PLANNING COMMISSION MEETING STAFF REPORT

DATE OF MEETING: October 8, 2019
NAME OF PROJECT: Lime Canyon Meadows
NAME OF APPLICANT: Brett Walker
AGENDA ITEM: Final
LOCATION OF ITEM: 960 West Lime Canyon Road
ZONING DESIGNATIONS: R-1-22

Subject: Lime Canyon Meadows Subdivision, Preliminary Review

Re: Lime Canyon Meadows
Hydrology Study and Proposed Improvements

LIME CANYON MEADOWS
MIDWAY CITY, WASATCH COUNTY, STATE OF UTAH
LOCATED IN THE NORTHEAST AND SOUTHEAST QUARTERS OF SECTION 28, TOWNSHIP 3 SOUTH, RANGE 4 EAST, SALT LAKE BASE AND MERIDIAN.
SCALE 1" = 60' FEET

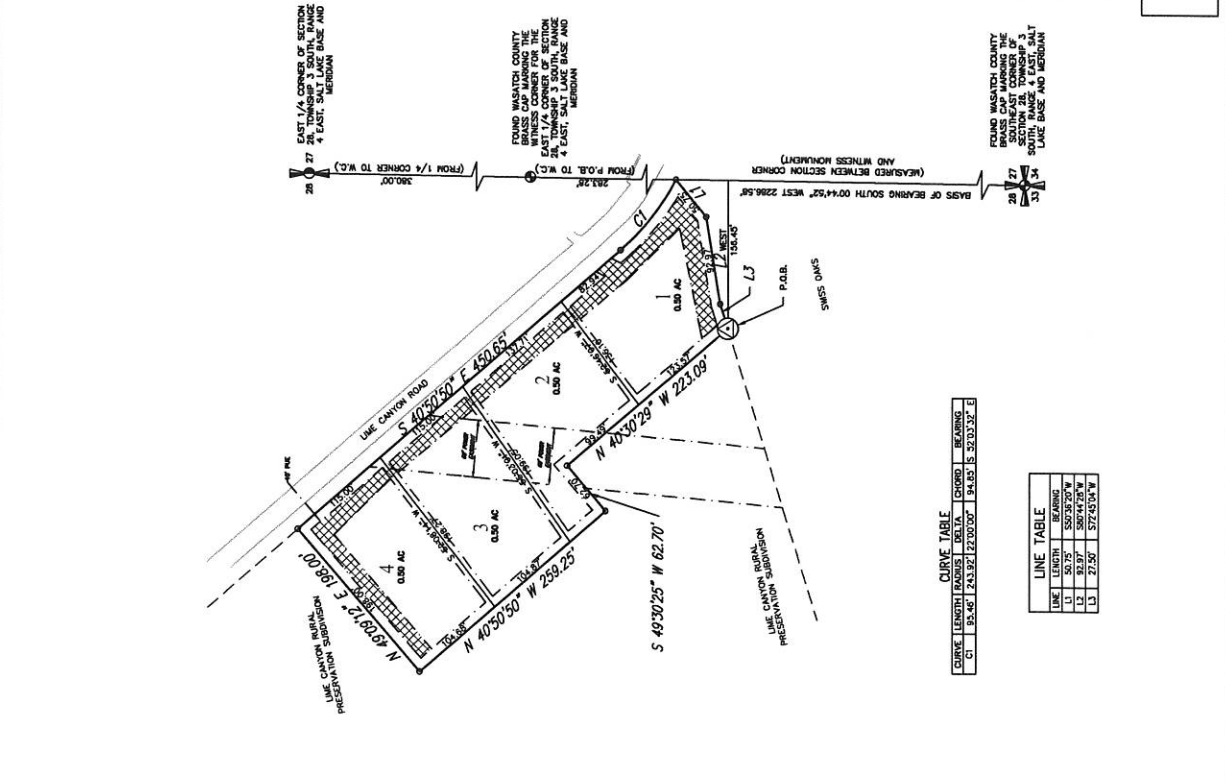
60’ Power Easement – A 60’ transmission line power easement crosses a section of the property. No buildings or trees will be allowed in this area as noted on the plat. The City will not approve any building permits in the easement area. Rocky Mountain Power will be responsible for enforcing any other rights associated with their easement.

DOUBLE EASEMENT NOTE:
NO BUILDINGS, STRUCTURES OR UTILITIES ARE LOCATED IN THE 60 FOOT POWER EASEMENT.

BRETT WALKER
 LIME CANYON MEADOWS
 LIME CANYON RUNOFF
 DETENTION

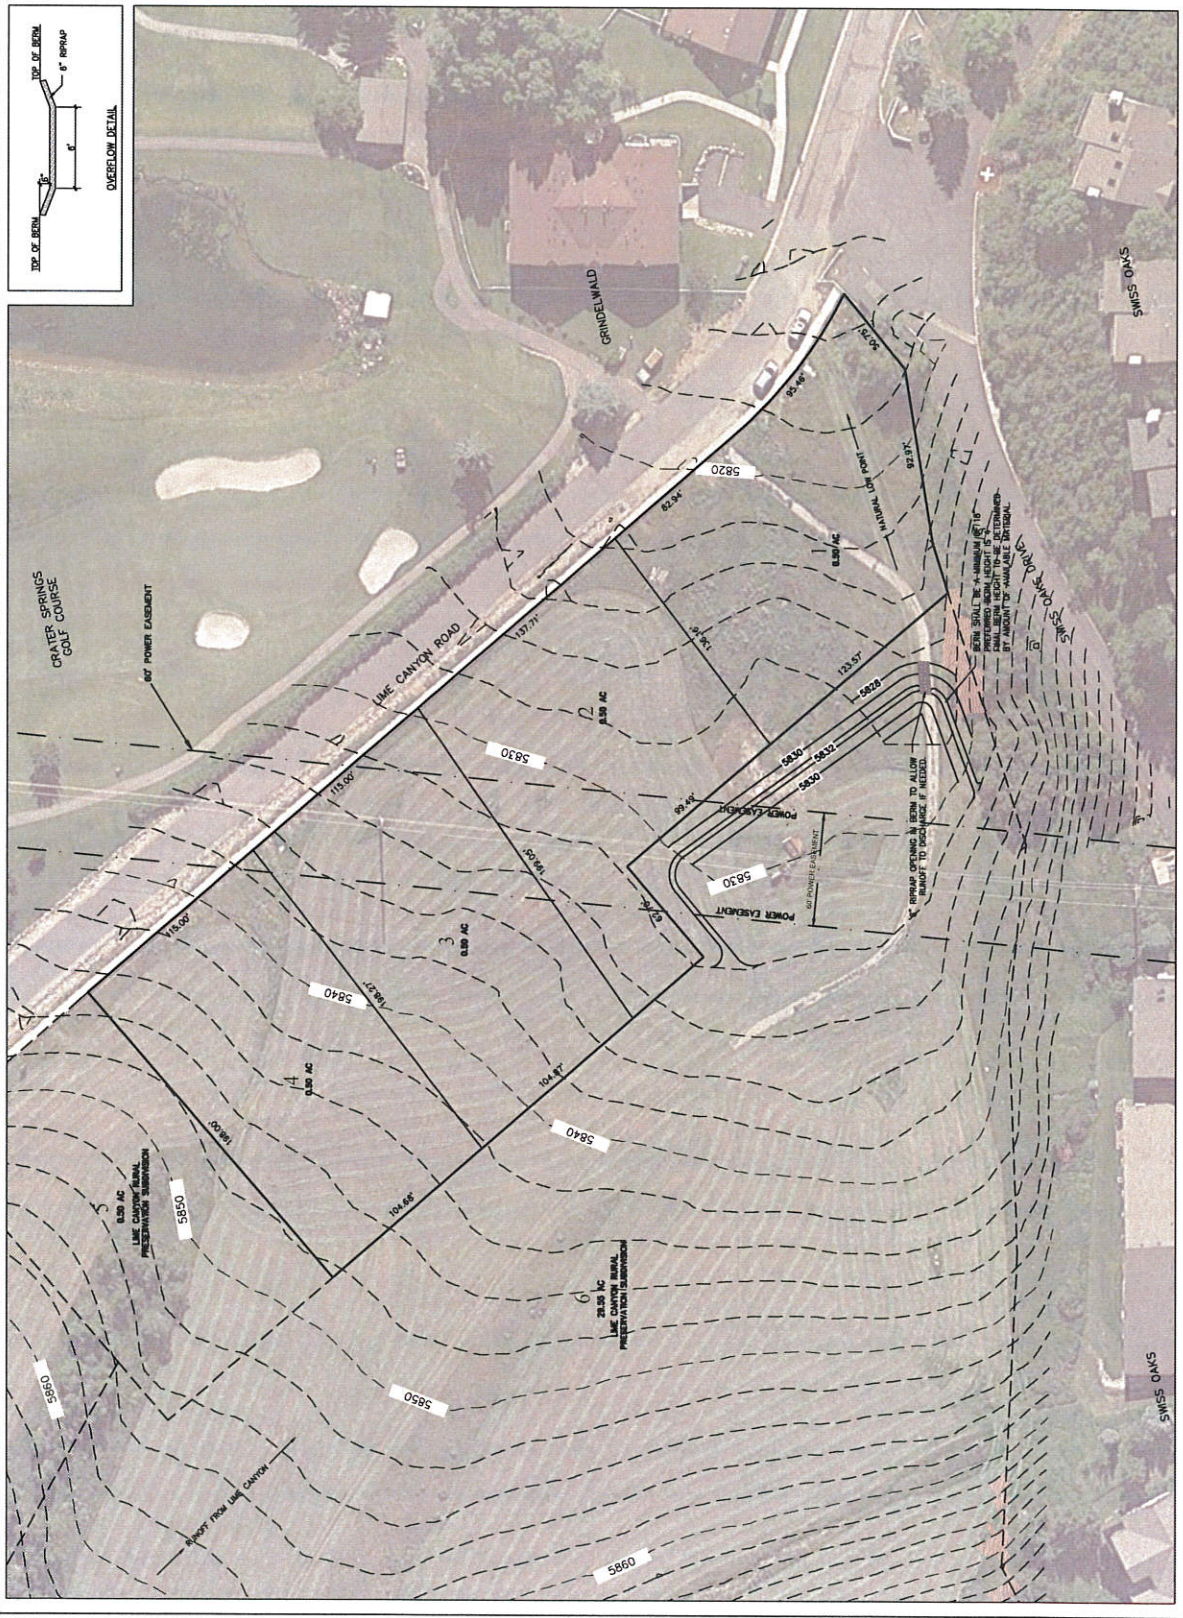
- The proposed subdivision is at the bottom of the Lime Canyon drainage. The recessed areas of this land is the final retention basin for all of Lime Canyon. To protect the safety of each of the proposed lots/homes, the high water line of the 100 year, 24 hour storm should be shown on the plans prior to final approval,
- The existing swales along Lime Canyon Road will accommodate the storm water runoff from Lime Canyon road.

1. Raise the top of the pond elevation by the Griffiths property to match the top of the pond elevation in the common area for the existing detention pond in the Lime Canyon Estates subdivision.

2. Lower the outlet grate elevation by one foot (1') on the existing detention pond in Lime Canyon Estates.
3. Increase the outlet grate to a thirty inch (30") diameter grate for the existing detention pond in Lime Canyon Estates.

4. Allow runoff that is released on to the Walker property to drain over the entire 4.59 acre drainage easement that is being preserved as a hay field. During a 24 hour period, the drainage easement can absorb 9.2 acre-feet of runoff assuming a low infiltration rate of 1.0 inches per hour and that the water is allowed to run over the entire easement.

5. Install a stock water feature on the Walker property. This water feature is anticipated to hold about one (1) acre foot of runoff. This feature will provide additional storm water retention storage for runoff from Lime Canyon.

6. Install a berm near the east property line of the Walker property and along the south side of the Lime Canyon Meadows subdivision. This berm will help provide an additional factor of safety against flooding for the homes in the Lime Canyon Meadows subdivision. The berm will also create additional storm water retention storage for runoff from Lime Canyon. The current discharge location for the property shall be maintained with the berm construction.

The berm will be constructed as material becomes available from other construction activities in the area. At a minimum, the final height of the berm should be 18 inches at the current discharge location. The final height of the berm may increase depending on the available materials. The final storm water storage capacity will depend on the final height of the berm.
